Illinois Route 31 Phase I Study:
Illinois Route 176 to Illinois Route 120
McHenry County

McHenry County College Shah Center
4100 W. Shamrock Lane
McHenry, Illinois 60050
Thursday, November 3, 2011
1:00 p.m. to 3:00 p.m.

Community Advisory Group (CAG) Meeting #3

Picture 3

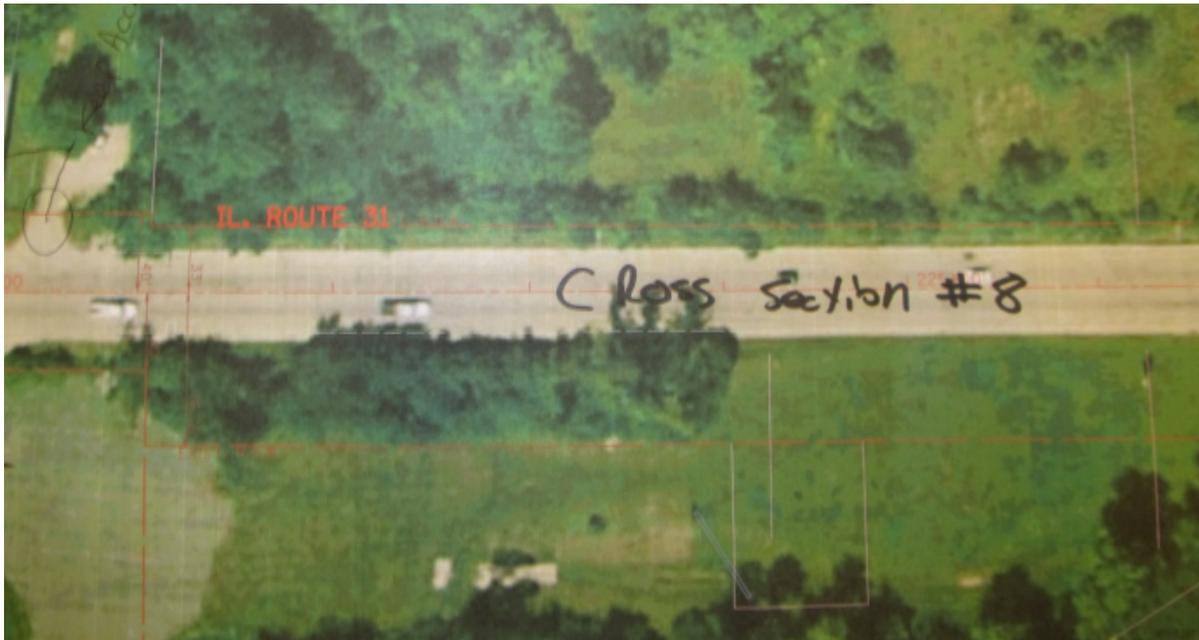
Comment 1: Just north of Half Mile Trail, there was a suggestion to avoid structures for TC Industries.

Comment 2: As mentioned in previous comments, the western Right of Way line should be held and that the eastern ROW line is adjusted for additional space. In addition to this, a similar supplemental comment was made to “widen” in the eastern direction.

Comment 3: There was a suggestion to “Keep Accesses” to TC industries. There are 3 driveways circled.

Picture 4

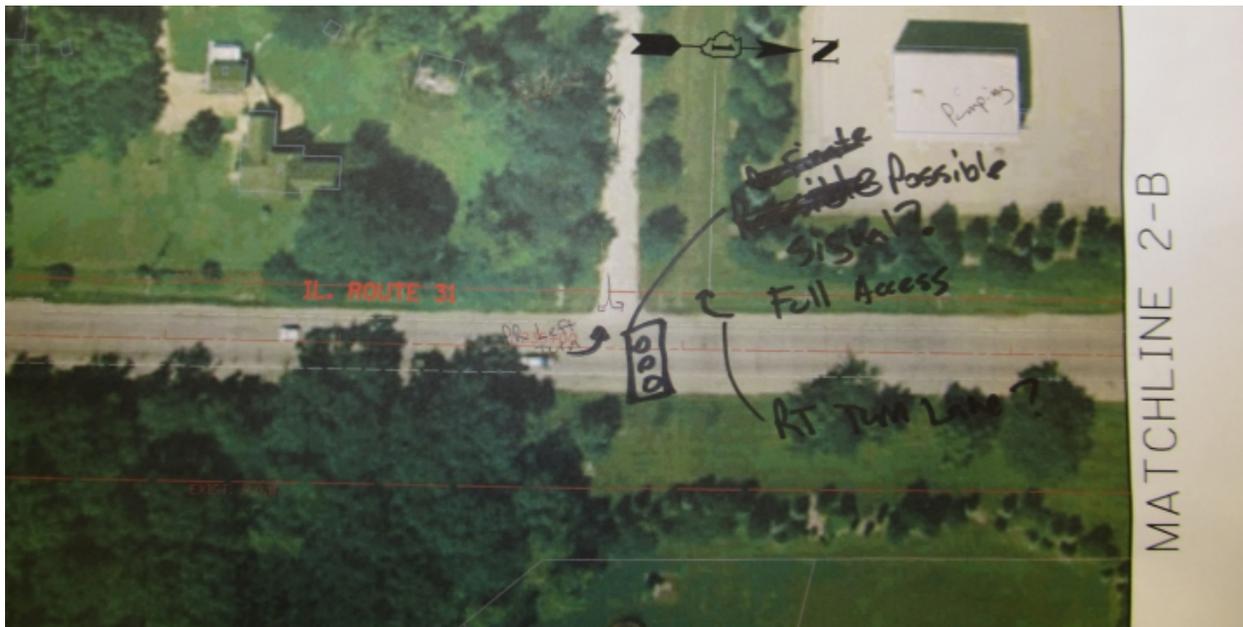
Comment 1: Cross section #8 was suggested for the roadway immediately north of Half Mile Trail past the 3 accesses to TC industries. Cross section #8 is a 22' raised median with two traffic lanes in each direction.

Picture 5

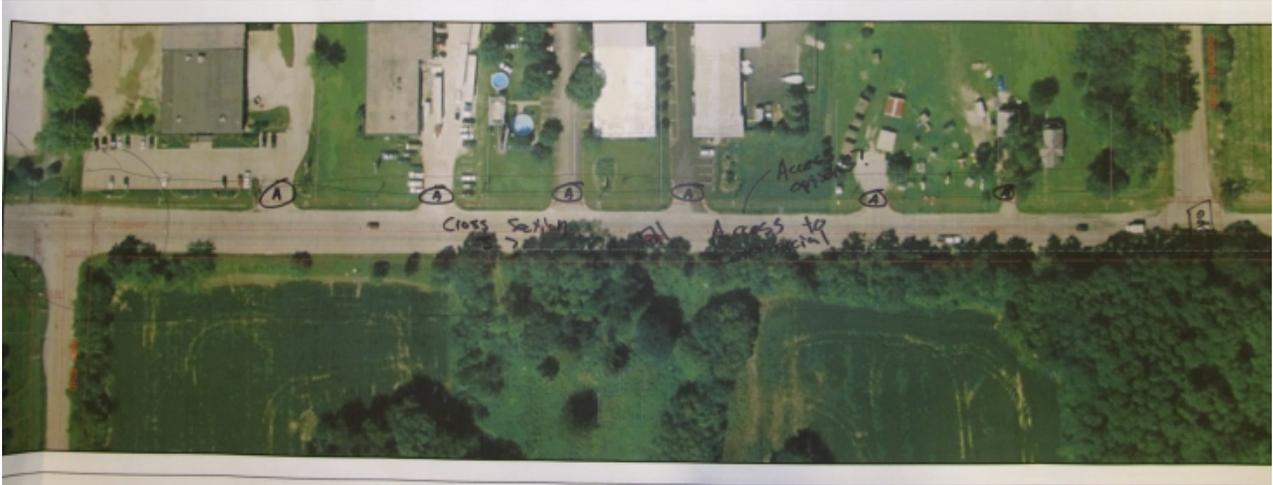
Comment 1: Cross section #8 was suggested for the roadway immediately north of Half Mile Trail past the 3 accesses driveways to TC industries. Cross section #8 is a 22' raised median with two traffic lanes in each direction.

Comment 2: Possible traffic signal location at the pumping station south of Ames Road. It was mentioned that this intersection should be improved for full access with a right turn lane for southbound movements and a left turn lane for northbound movements.

Comment 3: There was a note placed on a structure "pumping" and a note placed on the local road as "planning"

Picture 6

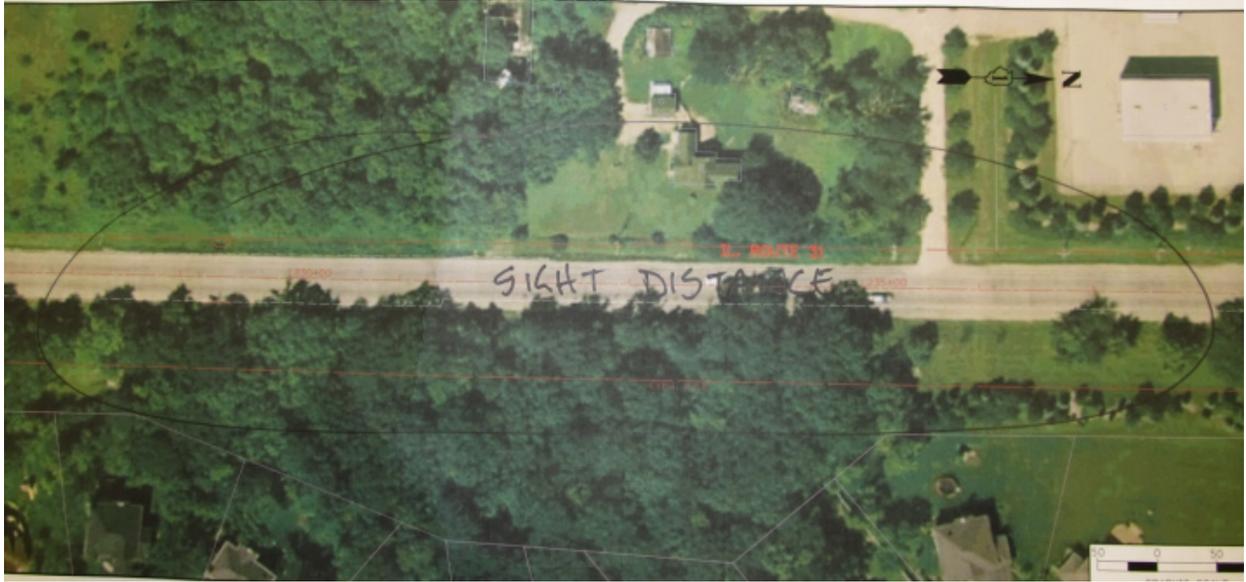
Comment 1: Between Ames and Edgewood Road, there are many accesses driveways to businesses that could be consolidated through frontage roads or other methods.

Comment 2: Cross Section #3 should be considered through this area, this cross section involves the use of a two way left turn lane (TWLTL).

Picture 1

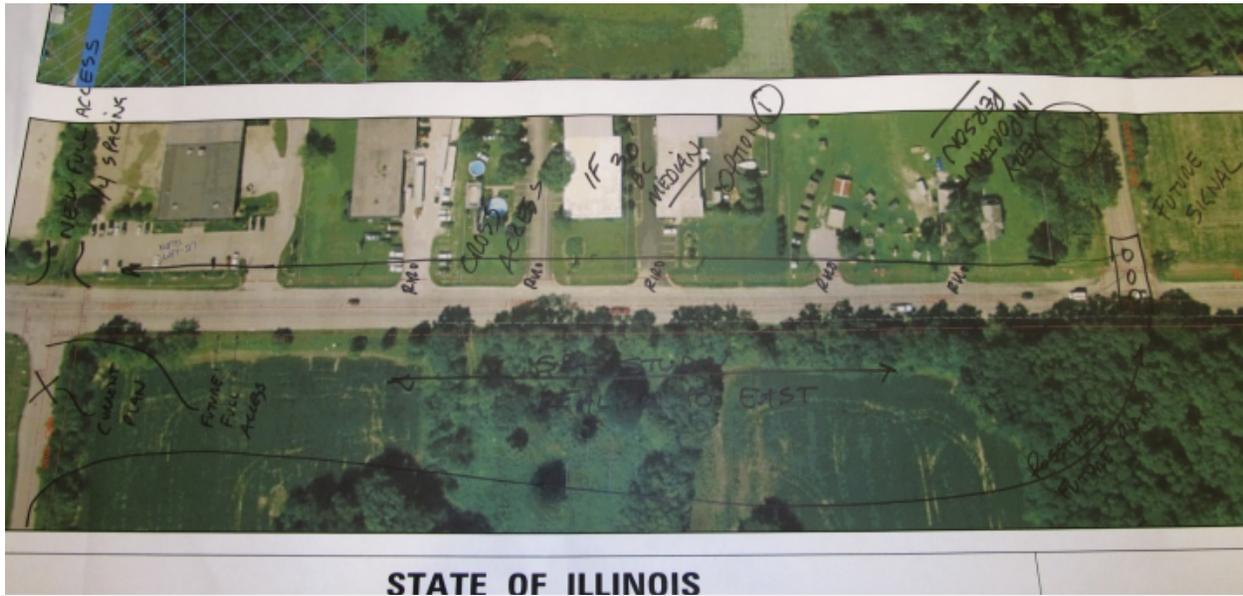
Comment 1: Sight Distance is a problem in the highlighted area. This area is south of a private drive, south of Ames Road and north of Half Mile Trail.

Picture 2

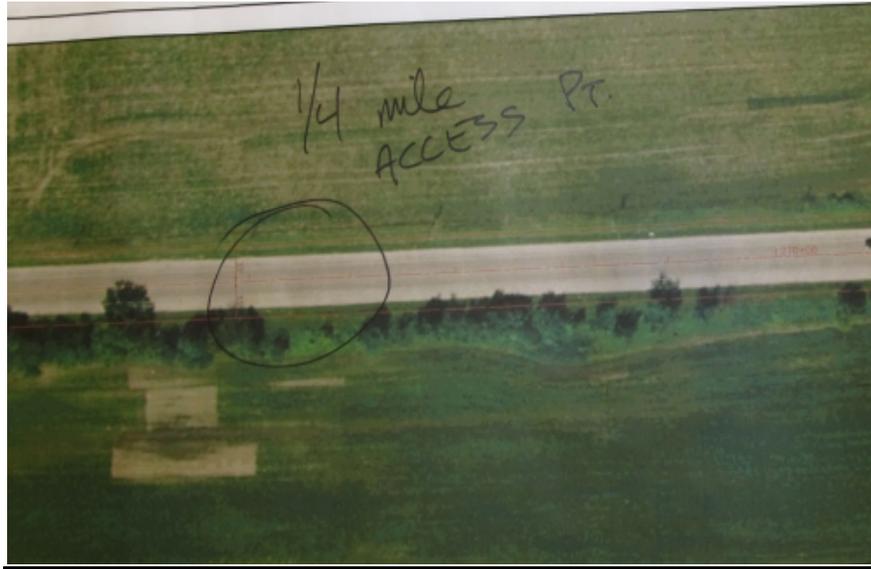
Comment 1: ¼ mile spacing between existing Ames Road and Edgewood Road. Both should have full access with a frontage road connecting the businesses in between and removing direct access to Route 31(west side of Route 31).

Comment 2: If a frontage road is not feasible, than have each access as a Right-in Right-out (RIRO).

Comment 3: Ames Road will be realigned with Edgewood Road in a different planned project. This project would also eliminate the current access Ames Road has with Route 31.

Comment 4: The alignment should be shifted to the east to minimize impacts to the businesses, their parking lots, and their accesses.

Comment 5: Edgewood Road is to be signalized (as part of a separate project).

Comment 6: Right of Way (ROW) acquisition on the south side of Edgewood Road should be minimized if frontage roads are constructed parallel to Route 31 to maintain accesses to businesses. A “very important person” would be impacted.

Comment 7: A new full access driveway (or frontage road access) was suggested for immediately south of the business immediately west of the intersection of Route 31 and Ames Road. This location is approximately ¼ mile south of Ames Road. The access should have a left turn lane along Route 31.

Picture 4

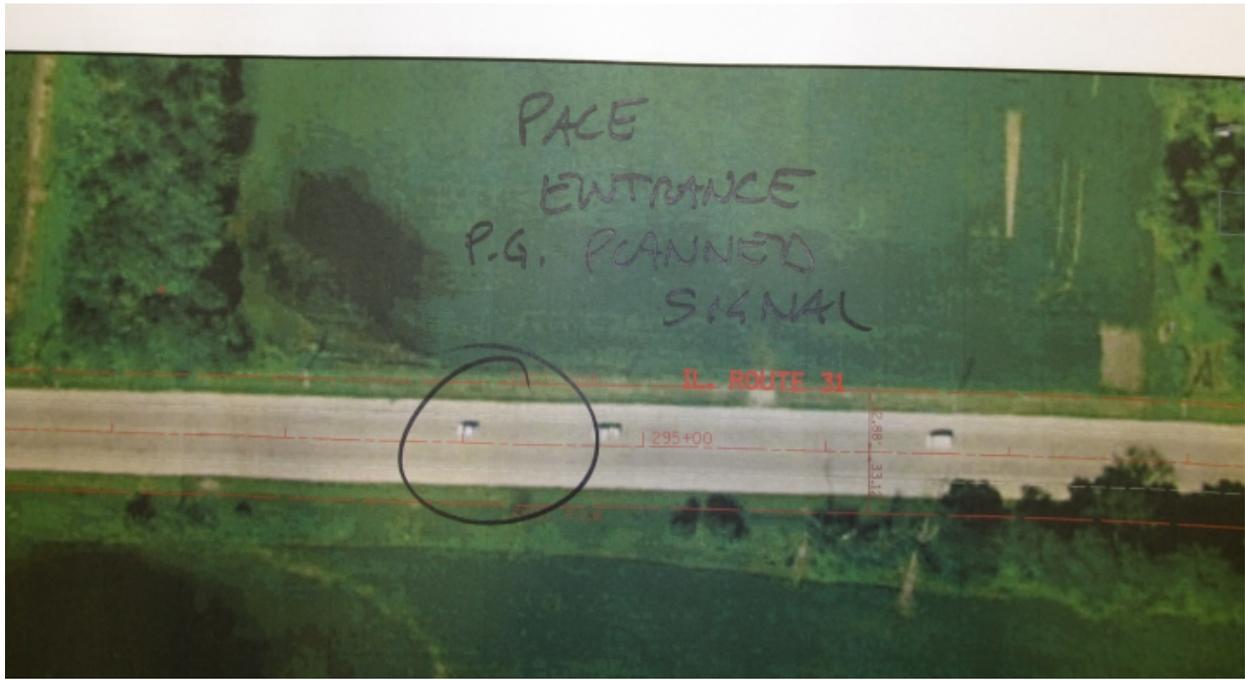
Comment 1: The Prairie Grove Town Center is proposed in this area, west of Route 31. The development includes extending Gracy Road to the west. A bike path overpass is proposed by the Village of Prairie Grove, south of Gracy Road. *(Based on post meeting review of the Village of Prairie Grove Town Center & Transit-Oriented Development Plan, the bike path is actually proposed north of the Gracy Road intersection; not as marked on the exhibit during the meeting.)*

Comment 2: Gracy Road would be signalized by the Village of Prairie Grove as part of their Town Center project.

Picture 5

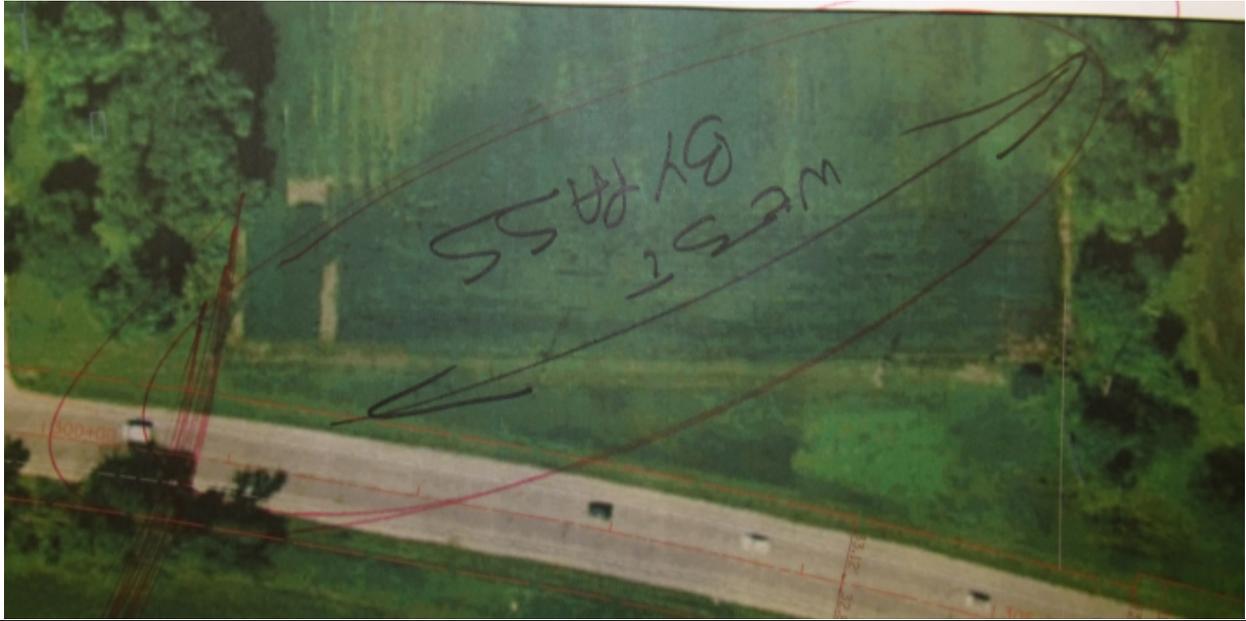
Comment 1: A new access road and Pace bus entrance is planned by the Village of Prairie Grove for the Town Center development. The new entrance is planned to include signalized traffic control. This location is approximately ¼ mile north of Gracy Road.

Picture 6

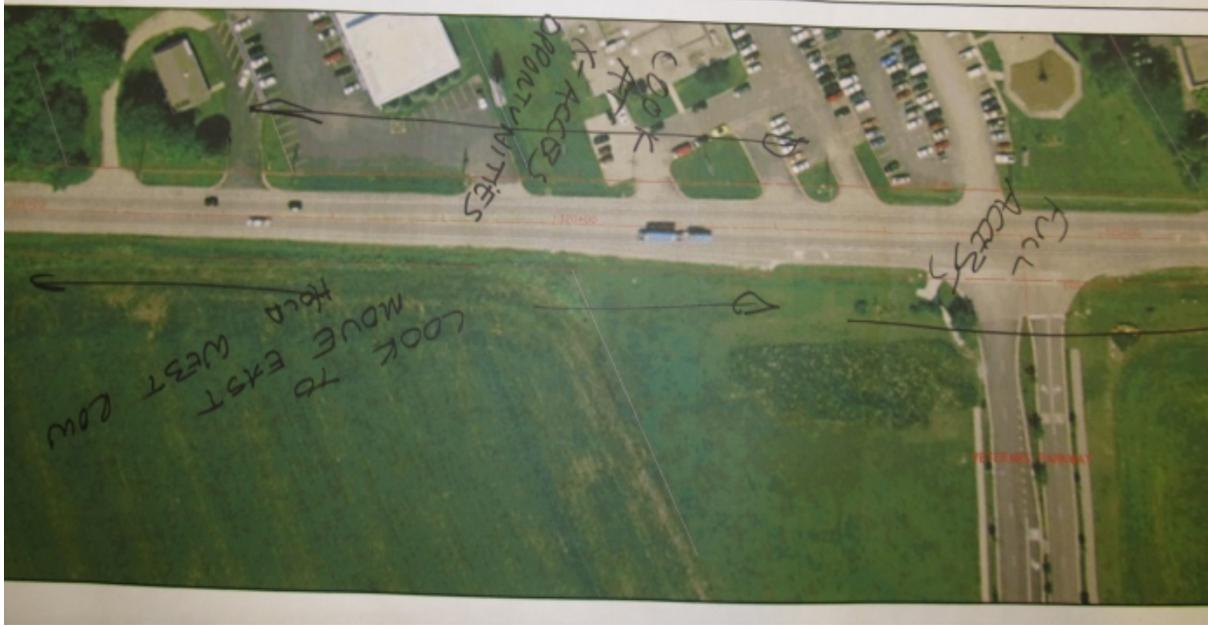
Comment 1: The McHenry West Bypass project could include a new interchange connection to Route 31 in this area. This area is between Gracy Road and Veterans Parkway. The PSG would investigate this bypass project to determine its status and history. Depending on the status of this project, Route 31 will have alternatives developed to meet the current transportation needs and regional planning developed by the state.

Picture 8

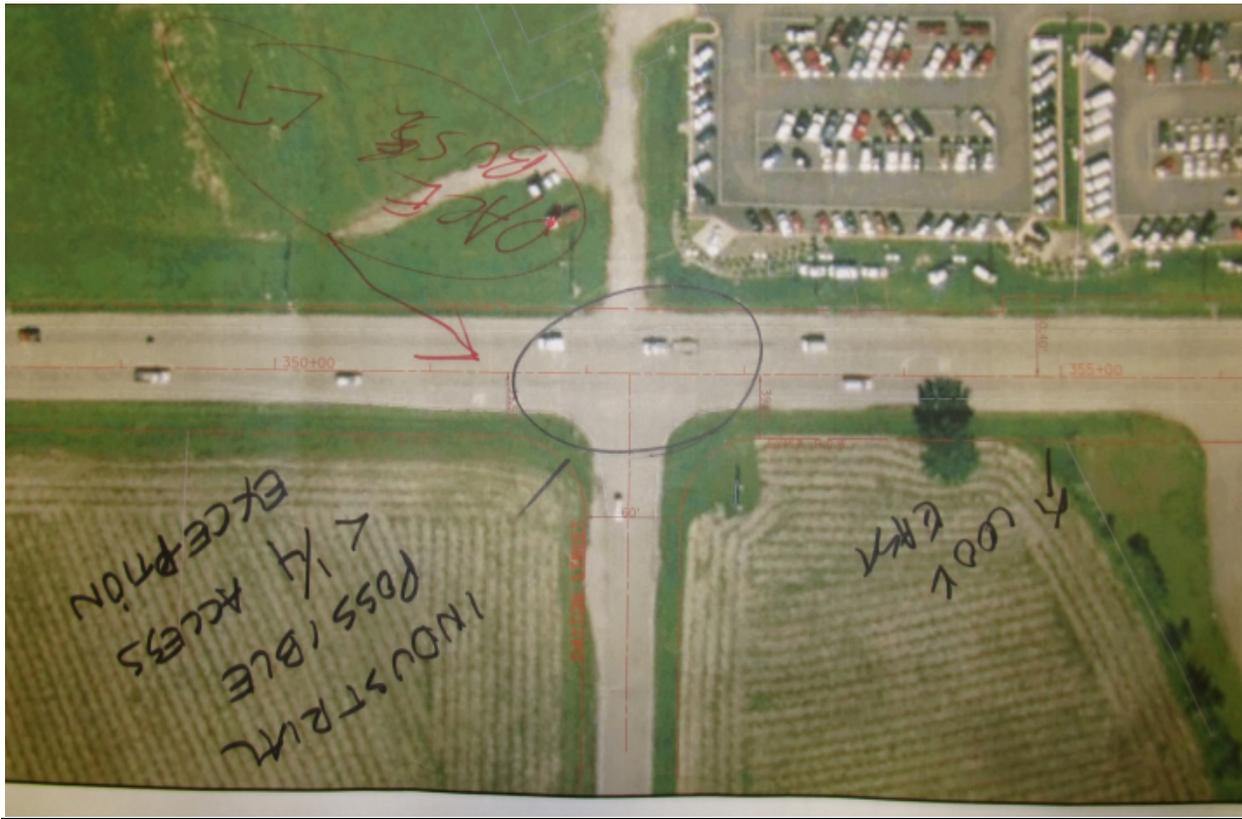
Comment 1: The intersection of Route 31 and Albany Street /Prime Parkway was identified as an existing traffic signal location and was noted that a “Pace Center” is planned to the west, along Prime Parkway.

Comment 2: As mentioned in a previous comment, the ROW acquisition should focus on the east and avoid impacts to the west of Illinois Route 31

Picture 10

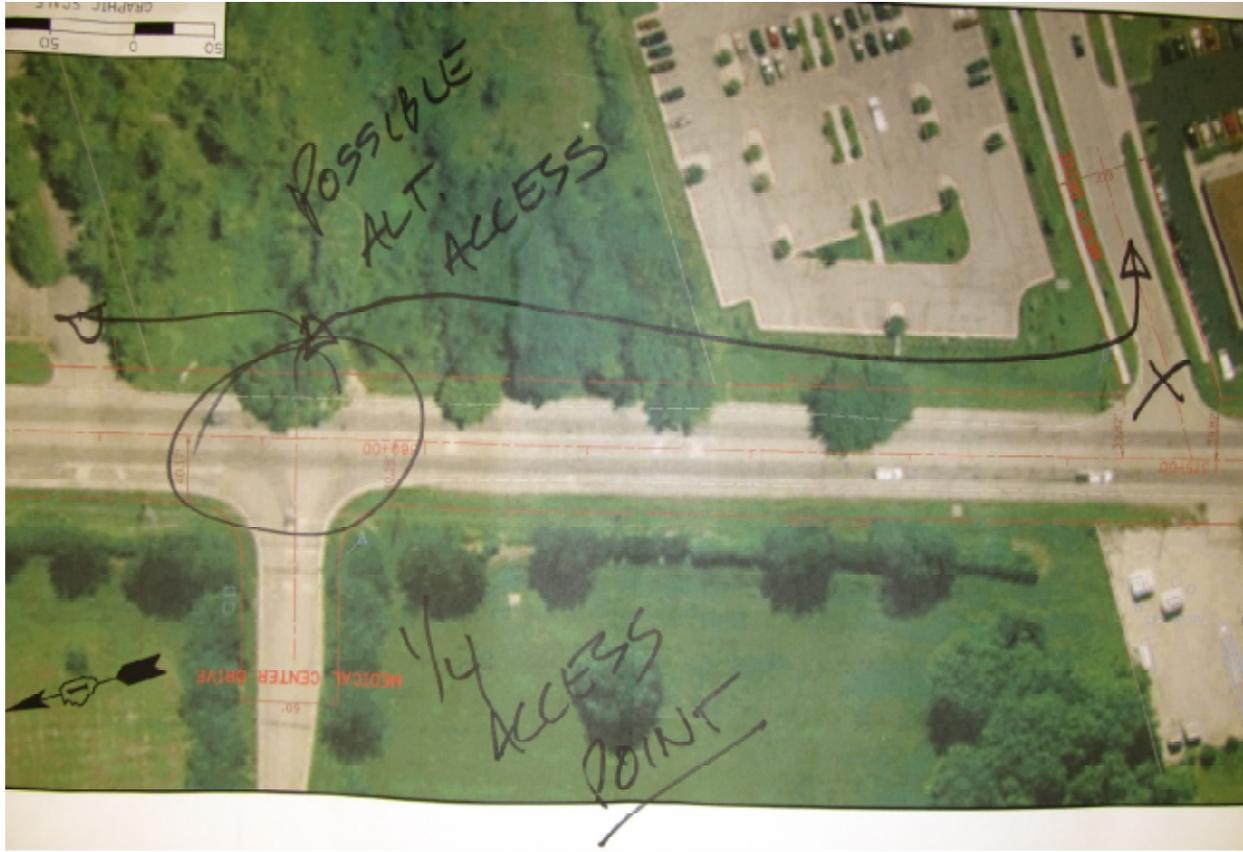
Comment 1: Shamrock Lane was identified as an existing signal location.

Picture 3

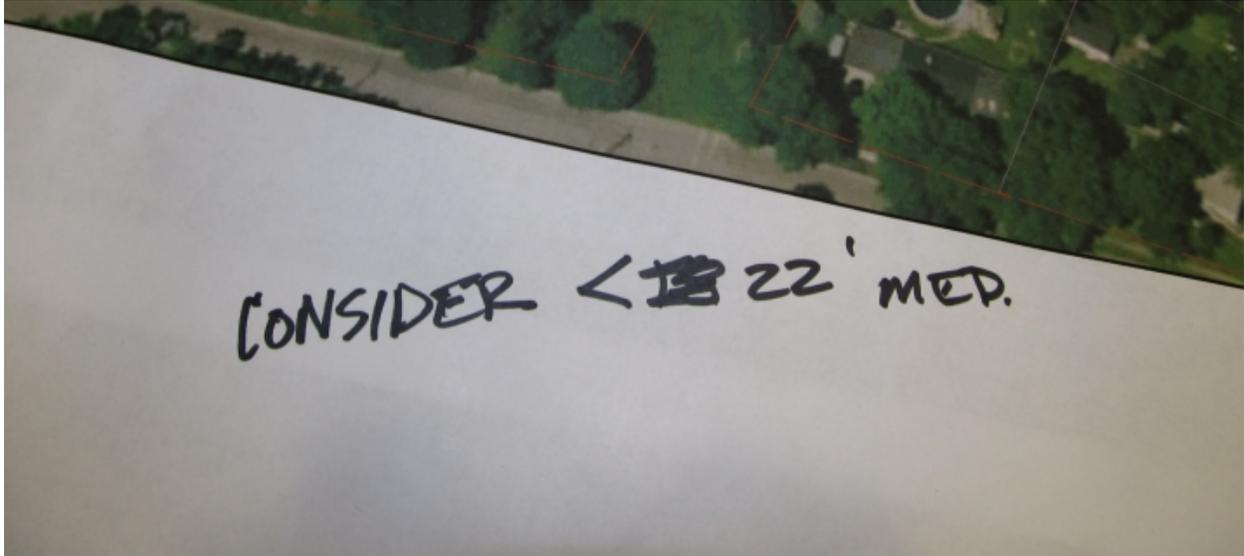
Comment 1: Suggestion to use 11' lanes in the downtown area to minimize impacts

Comment 2: Suggestion to eliminate parking north of Main Street.

Comment 3: There is already quite a bit of parking along many of the side streets. Consider elimination of all parking along IL Route 31. If necessary, additional parking can be provided via new parking lots.

Comment 4: Consider converting closely spaced side streets (i.e. Waukegan Road) to Cul-de-sacs. If cul-de-sac is not possible, make some of the side streets right-in and right-out only.
